CORRECTIVE MEASURES STUDY WORK PLAN MEMBRANE INTERFACE PROBE PHASE
2 PILOT STUDY SOLID WASTE MANAGEMENT UNIT 166 (SWMU 166) ZONE K CNC
CHARLESTON SC
2/1/2001
CH2M HILL

Re: Corrective Measures Study (CMS) Work Plan for Phase II Membrane Interface Probe (MIP)
Pilot Study for SWMU 166 located in Zone K Annex of the Charleston Naval Complex,
SCO 170 022 560, Revision 1.0, dated February 2001, received February 5, 2001.

Zone K, SWMU 166; Corrective Measures Study Work Plan
Membrane Interface Probe (MIP) Phase II Pilot Study
Dated February 2001, Received 5 February 2001

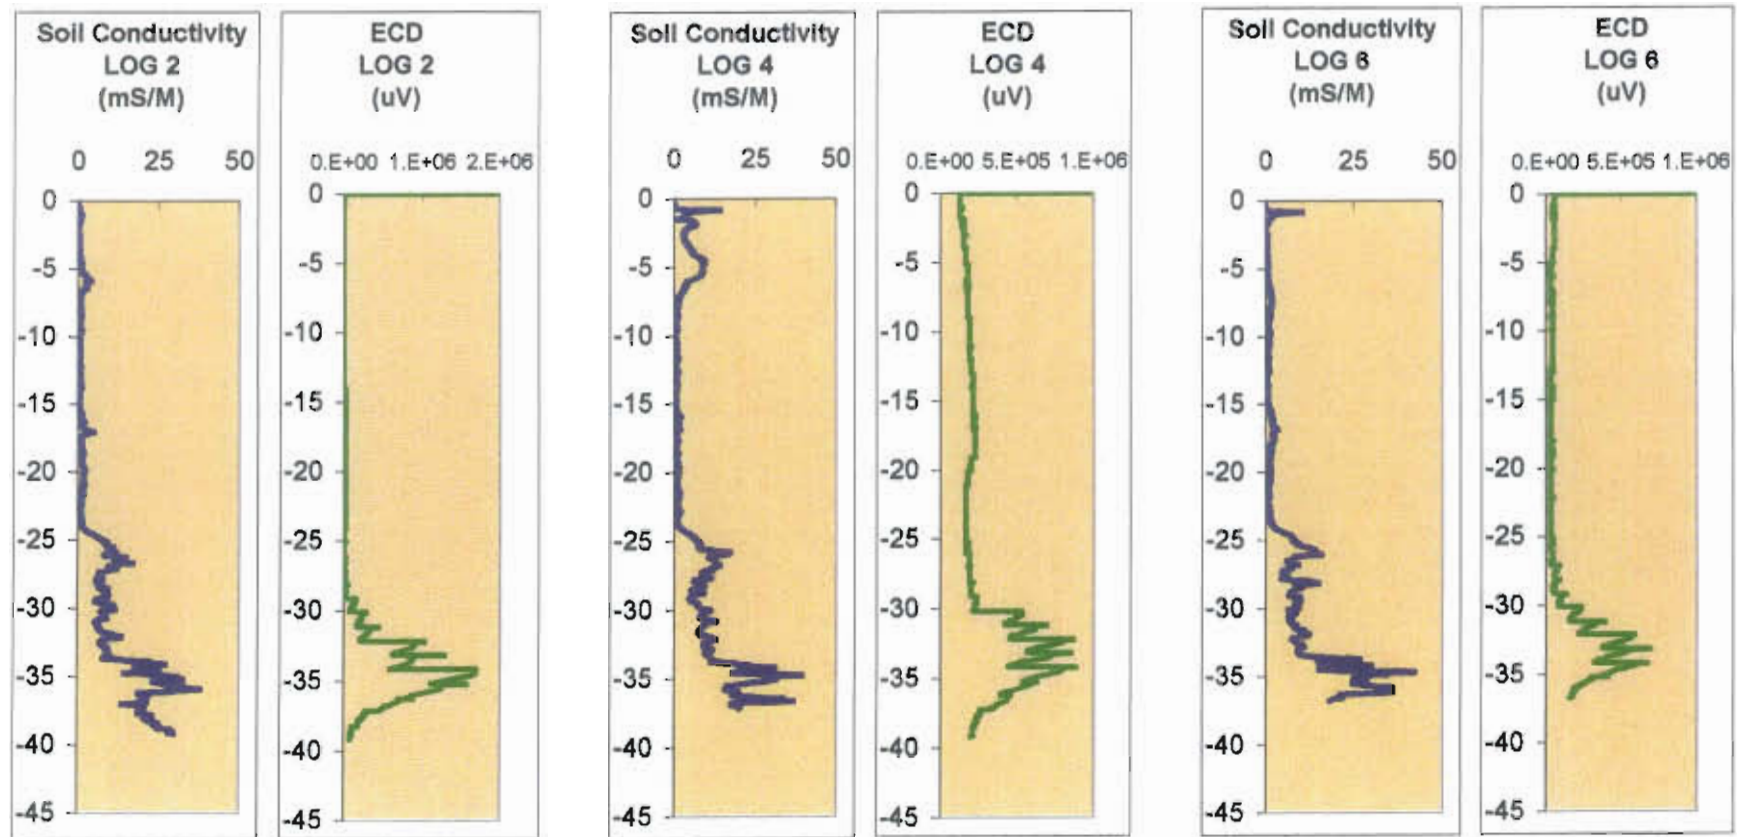
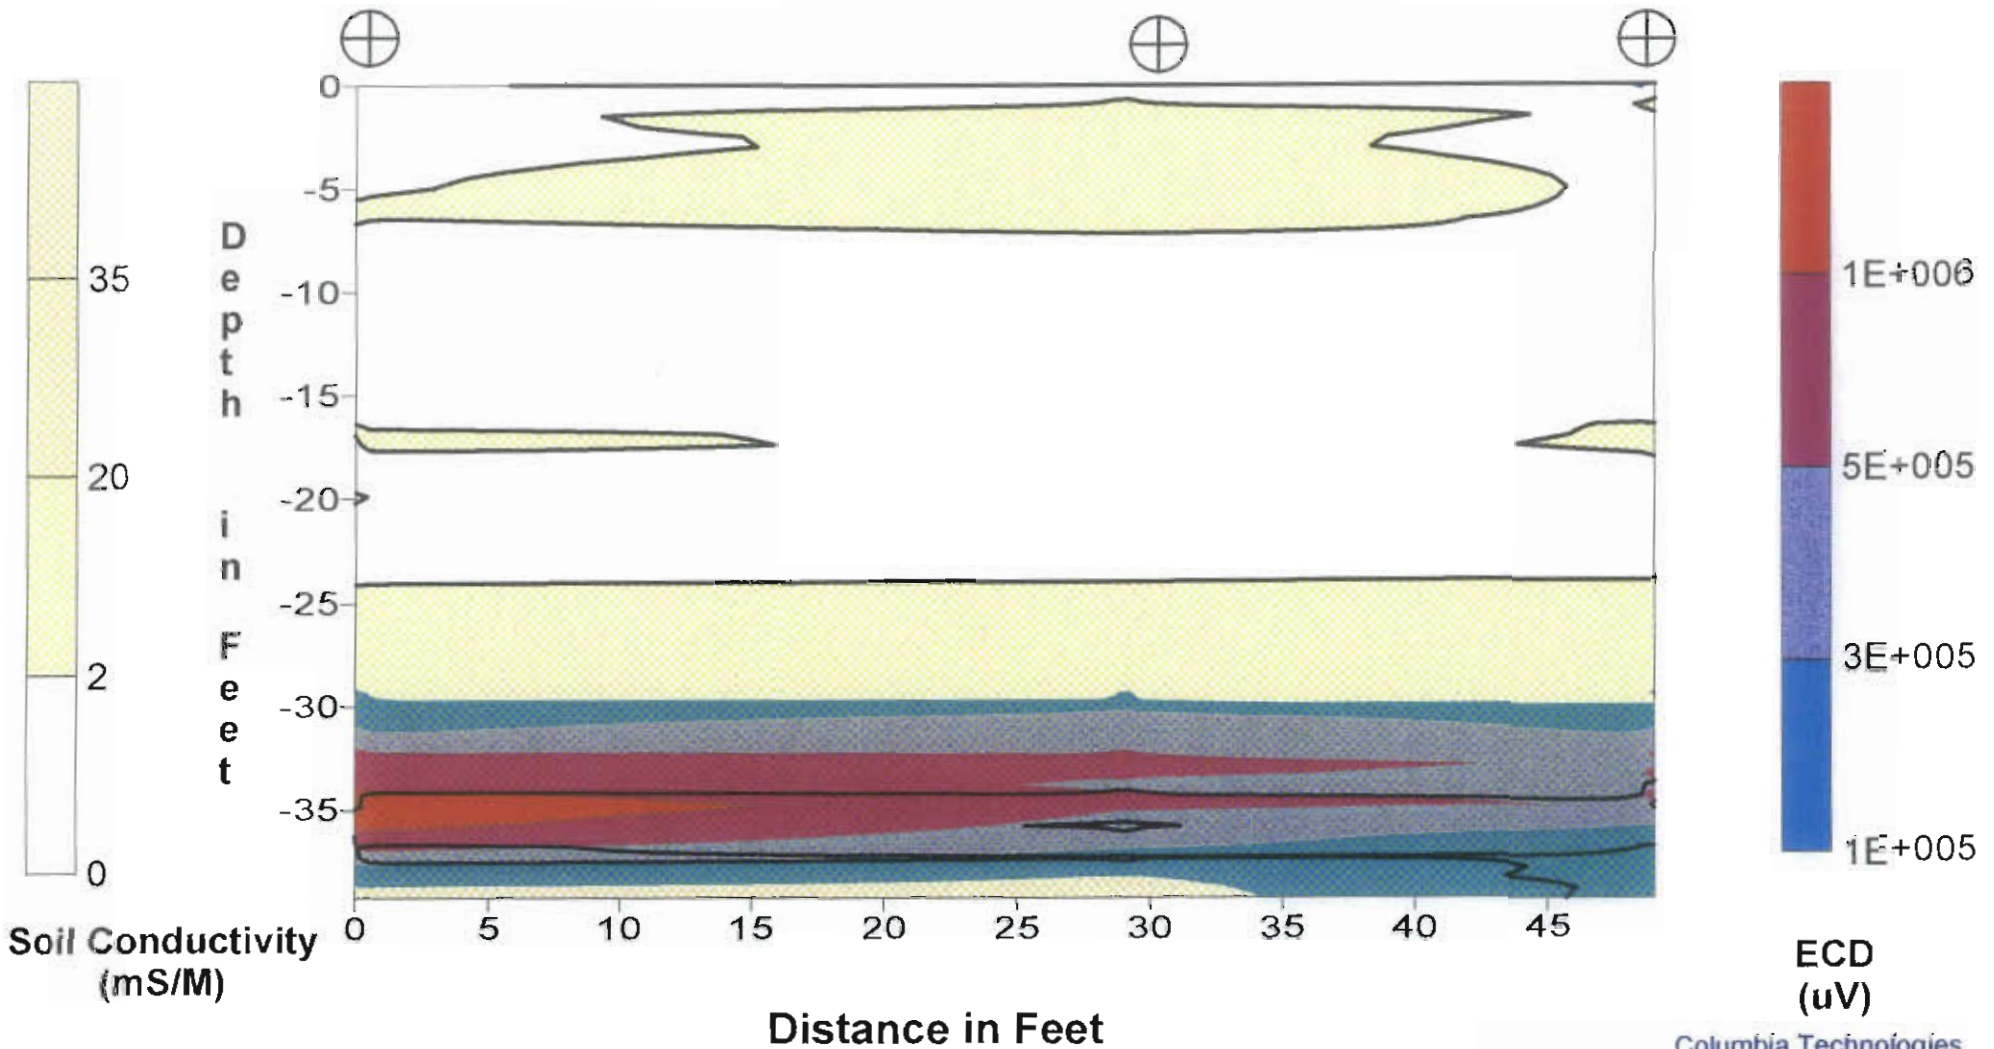
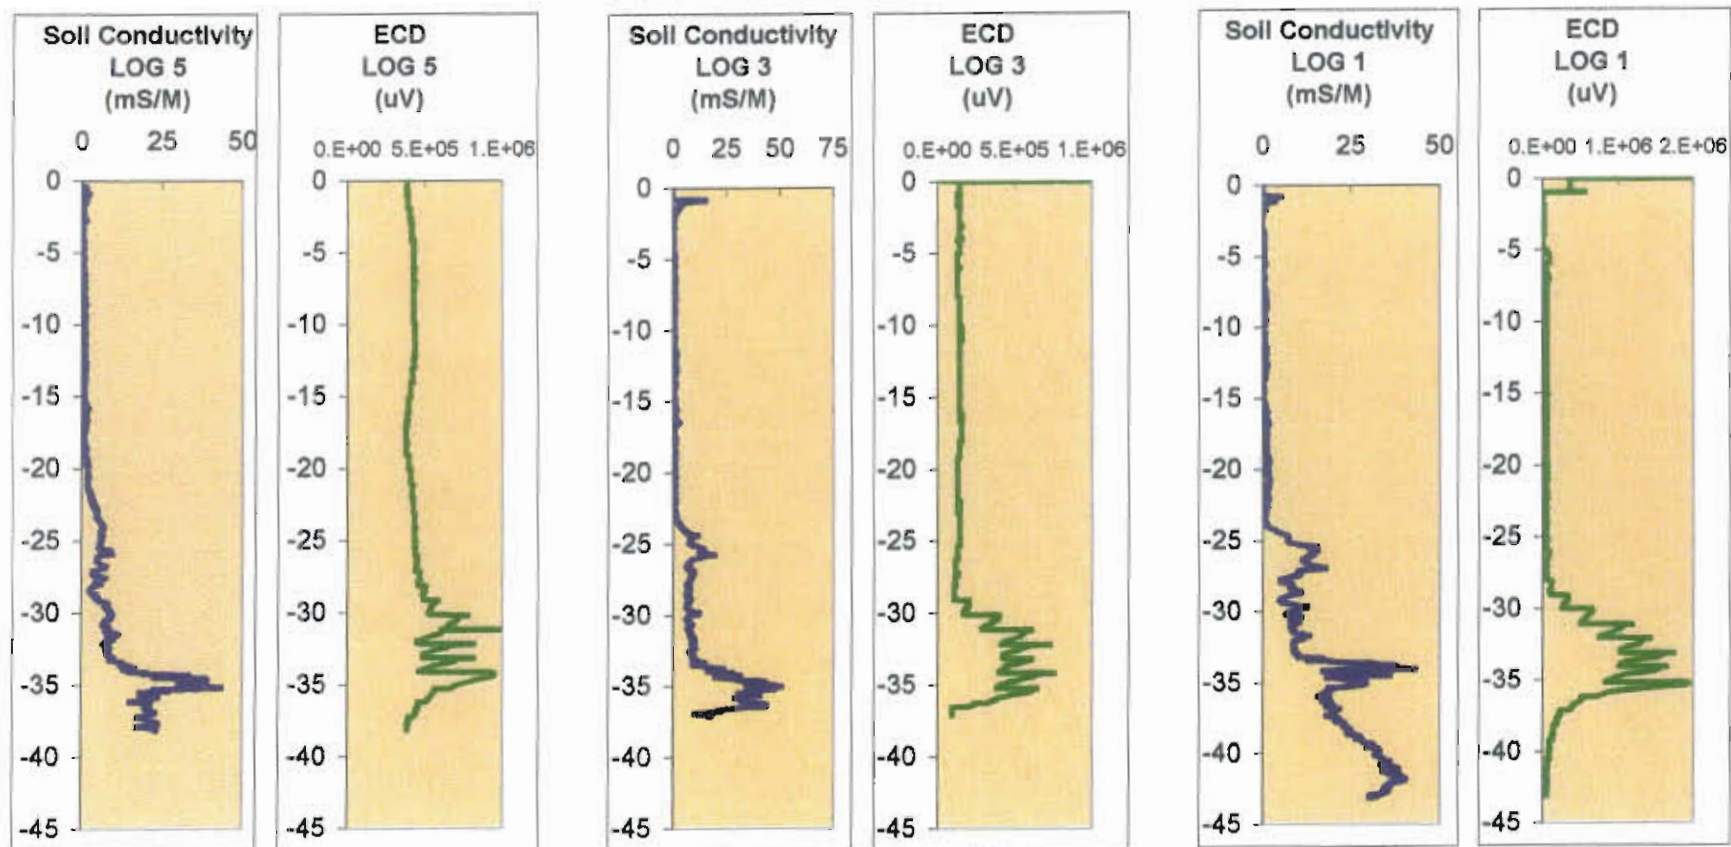
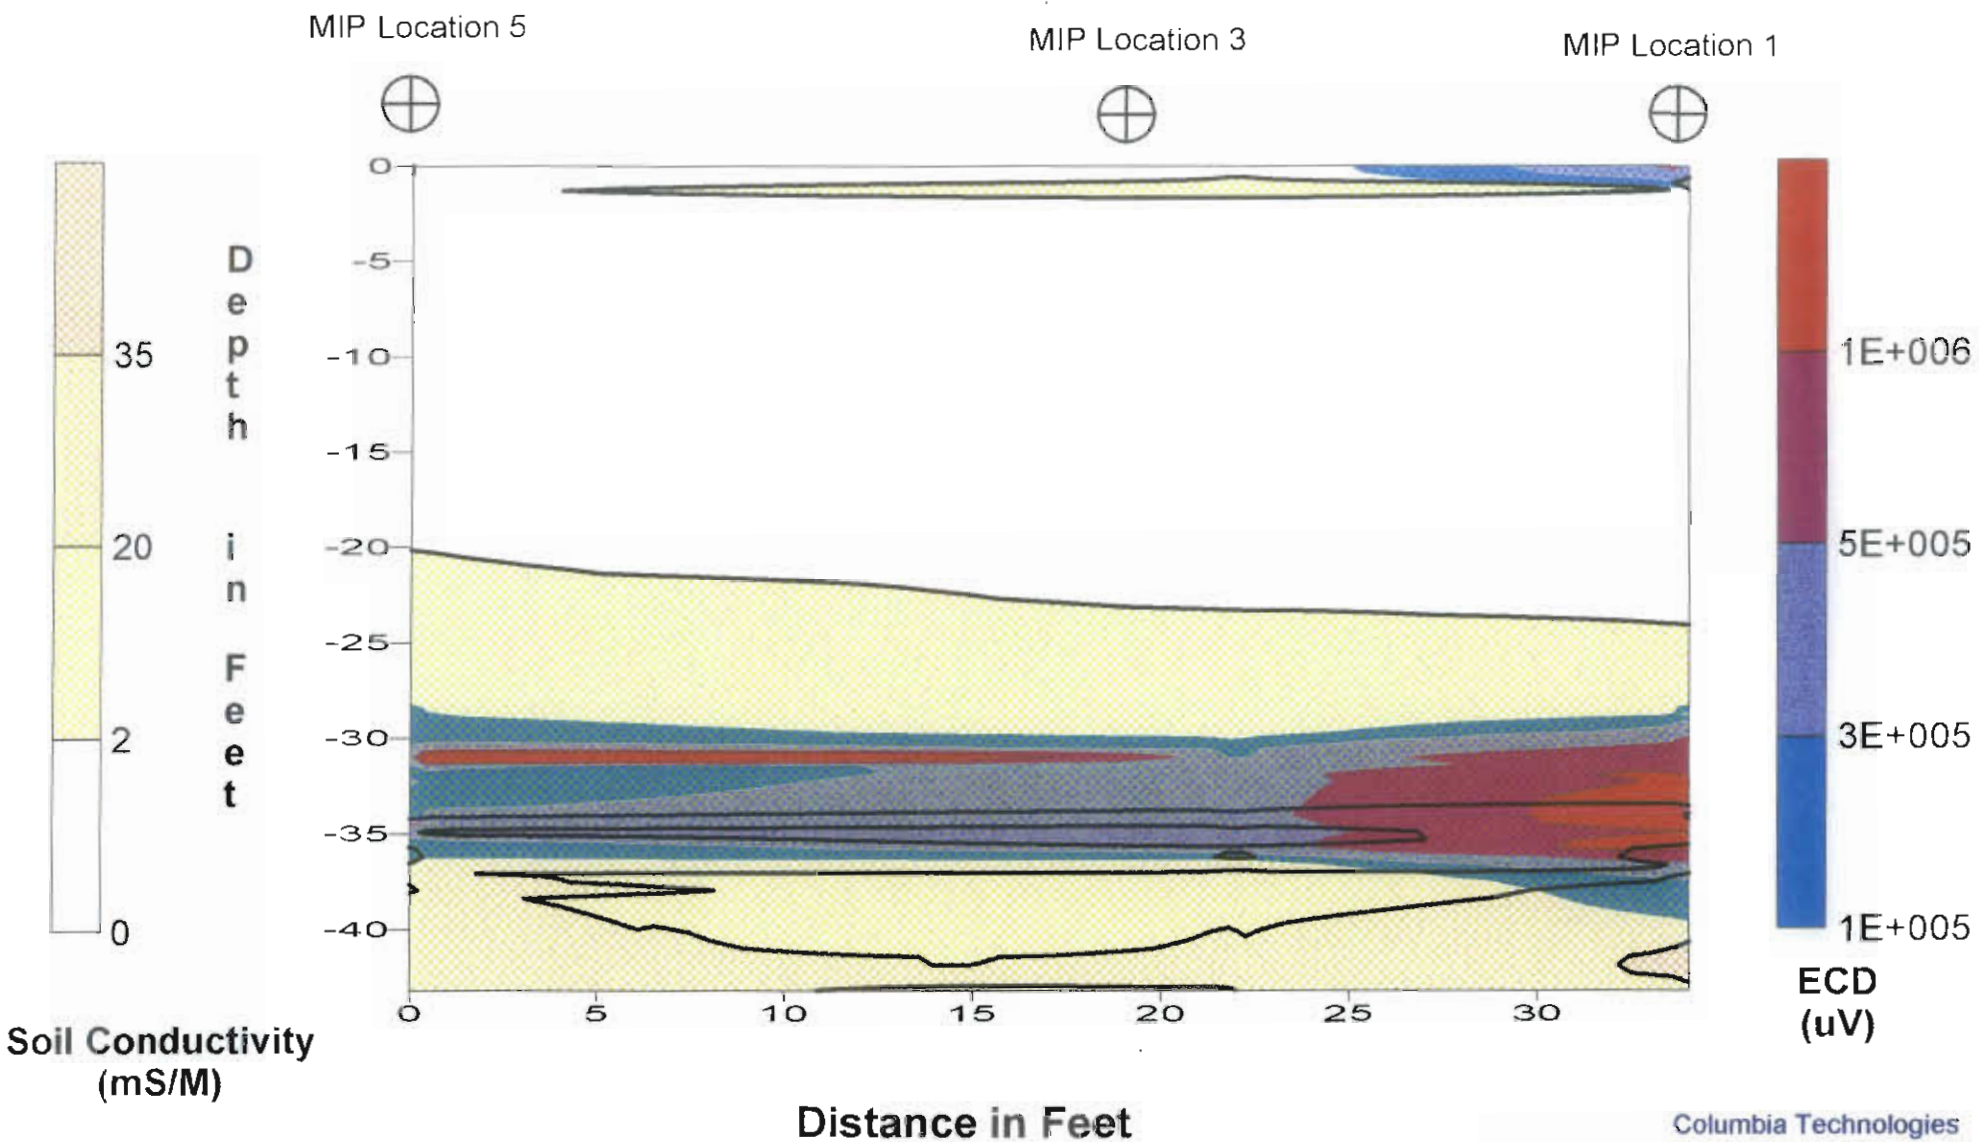
It is not clear on these figures if the well and sample elevations are from Mean Sea Level or have been measured from the surface at that location. This could have significant impact on data interpretation. Revisions to this document are not necessary, however future workplans and reports should clearly reference the elevation datum.

Each of the Figures A-2a through A-2d depicting the soil conductivity and ECD response as a function of depth initiates at a reference datum of zero indicating the land surface. This nomenclature is consistent with the text provided in the appendix, which references the soil conductivity and ECD response as a function of feet below land surface.

4. Figure A-3. Comparison of MIP Results with Vertical Profile Water Samples.

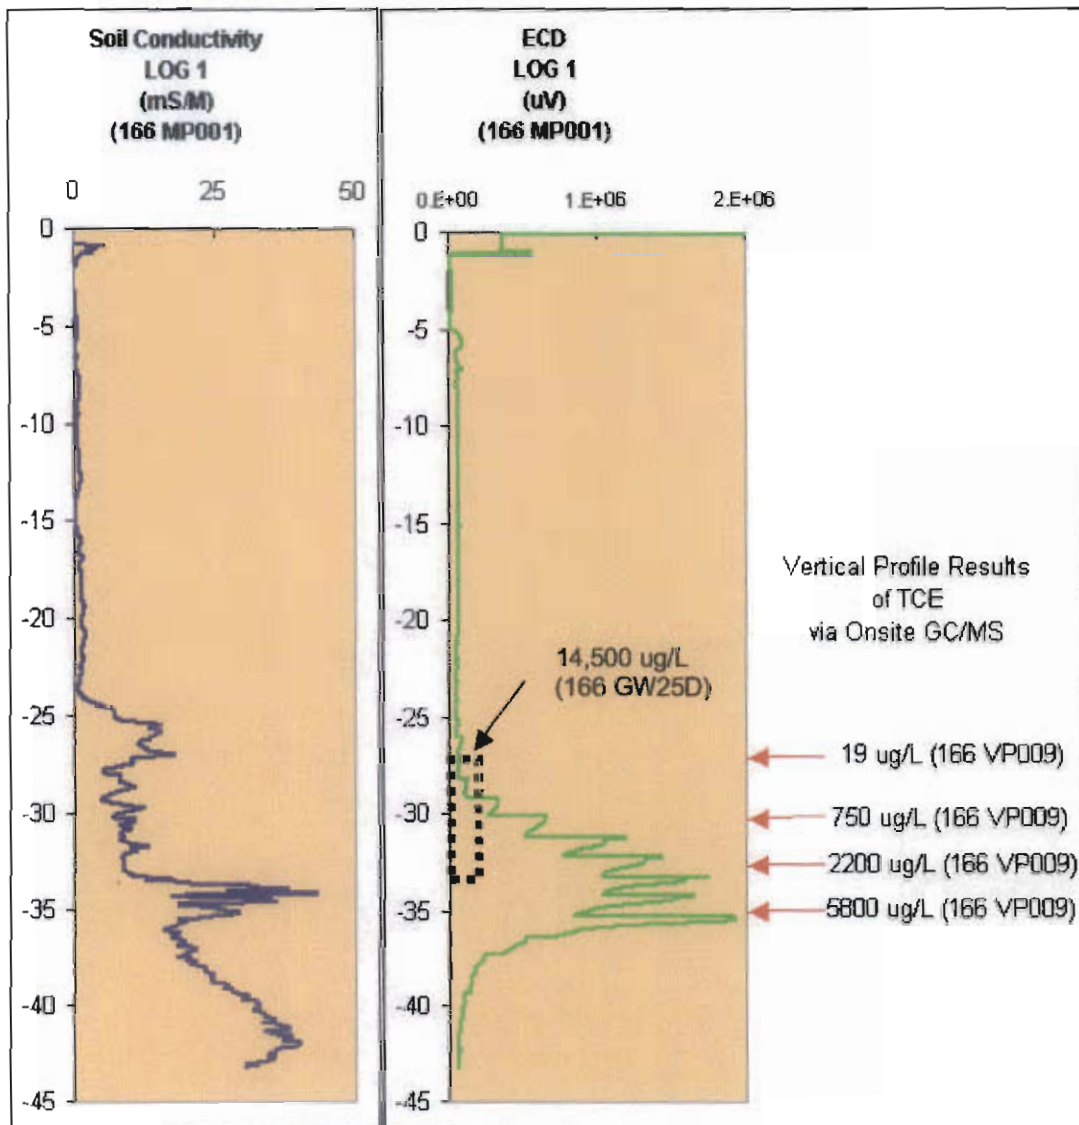
The figure fails to indicate what sample location(s) were used to illustrate the comparison of MIP results with vertical profile water samples.

Also, the Department recommends the Navy to provide similar illustrative figure for comparing results from groundwater well 166GW25D, vertical profile water sample 166VP009, and MIP boring 166MP001. The text on pages A-2 and A-3 describes the results for these sample locations.

"Figure A-3 provides a graphical comparison of the ECD and soil conductivity results from 166MP001 with the groundwater analytical results from the samples collected from the adjacent vertical profiler point 166VP009. Figure A-3 presents the best correlation of the ECD readings to the groundwater analytical results using the GC/MS." Figure A-3 will be revised to identify the analytical results from the vertical profiler 166VP009 and 166GW25D with the ECD and soil conductivity results from 166MP001.

In addition, table A-3 will be added to appendix A that will provide the ECD response and the analytical results from the adjacent vertical profiler samples as a function of depth.

Because groundwater samples were collected at 4 discrete depths [i.e., 27, 30, 32, and 35 feet below land surface (ft bls)] from the vertical profiler point 166VP009 it was selected as the preferred comparison to the ECD response from the adjacent MIP boring 166MP001. The sample collected from the monitoring well 166GW25D was compared to approximately 5 feet (i.e., well screen from 27.5 to 32.2 feet below land surface) of continuous ECD response from 166MP001. This 5-foot length covers an ECD response range from the baseline to approximately 1.5E+06 microvolts. The analytical results from the samples collected from 166VP009 using the 6-inch well screen can be compared to 4 different 6-inch discrete ranges of ECD response.
